UNITED STATES PATENT AND TRADEMARK OFFICE

APPLICATION NO.	FILING DATE	FIRST NAMED INVENTOR	ATTORNEY DOCKET NO.	CONFIRMATION NO.
09/691,337	10/18/2000	Jens Wildhagen	450117-02753	5220

Office Action Summary

Figure 2

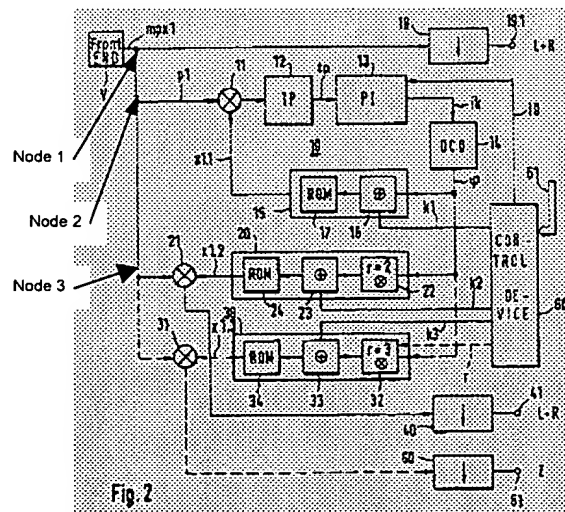
3. Claims 14, 15, 26, 34, and 42 are rejected under 35 U.S.C. 102(e) as being anticipated by Noeske et al. (Hereinafter "Noeske") (US Patent 6,351,631).

Regarding Claims 14 and 26, Noeske discloses a method to retrieve RDS information (Front END (V) to node 1) by filtering and transforming an incoming multiplex signal into an amplitude demodulated RDS signal, characterized in that an amplitude modulated RDS signal (signal from (31) to (50)) is derived on basis of a first intermediate signal (signal from node 1 to (21)) obtained during an extraction of a stereo-difference signal from the incoming multiplex signal (extraction of difference of multiplex signal at (21) starts from separation of signal at node 1 and continues through (21)), wherein said first intermediate signal lies along a signal path separate from a signal path of an extraction of a stereo sum signal from the incoming multiplex signal (node 1 to (19)), and said first intermediate signal (node 1 to (21)) is distinct from intermediate signal obtained during said extraction of said stereo-sum signal (node 1 to (19)) from said incoming multiplex signal.

Regarding Claims 15 and 16, Noeske discloses a method for retrieving RDS information from a multiplex signal (Front END (V) to node 1), comprising the steps of: obtaining, from said multiplex signal, a first intermediate signal from which a stereo-difference signal of said multiplex signal can be extracted (signal from node 1 to (21) and (31)); extracting from said multiplex signal, a stereo-sum signal (signal from node 1 to (19)); and deriving an amplitude modulated RDS signal on the basis of said first intermediate signal (signal from (31) to (50)), wherein said obtaining of said first intermediate signal is separate from said extracting of said stereo-sum signal; and said first intermediate signal is distinct from said multiplex signal (signal from node 1 to (21) and (31) is distinct from multiplex signal from (V) to node 1). Noeske further discloses

Regarding Claim 34, Noeske discloses an apparatus for retrieving RDS information from a multiplex signal (signal from (V) to node 1) comprising: means configured and adapted for obtaining, from said multiplex signal, a first intermediate signal (signal from node 1 to (21) and (31)) from which a stereo-difference signal of said multiplex signal can be extracted (21); means configured and adapted for extracting, from said multiplex signal, a stereo-sum signal (signal path from node 1 to (19)); and means configured and adapted for deriving an amplitude modulated RDS signal on the basis of said first intermediate signal ((31) to (50)), wherein said means for obtaining said first intermediate signal is separate from said means for extracting said stereo-sum signal; and said first intermediate signal is distinct from said multiplex signal (node 1 to (21)) is distinct from intermediate signal obtained during said extraction of said stereo-sum signal (node 1 to (19)).

Regarding Claim 42, Noeske discloses a apparatus for retrieving RDS information from a multiplex signal, comprising: a first signal path (node 1 through (21)), via which a stereo-difference signal is extracted from said multiplex signal (21); a second signal path, separate from said first signal path, via which a stereo-sum signal is

extracted from said multiplex signal (node 1 to 19); and a third signal path, branching from said first signal path (node 3 to 31), via which said RDS information is retrieved; and mixing means (21) situated along said first signal path upstream from a branching off point (node 3) of said third signal path from said first signal path.
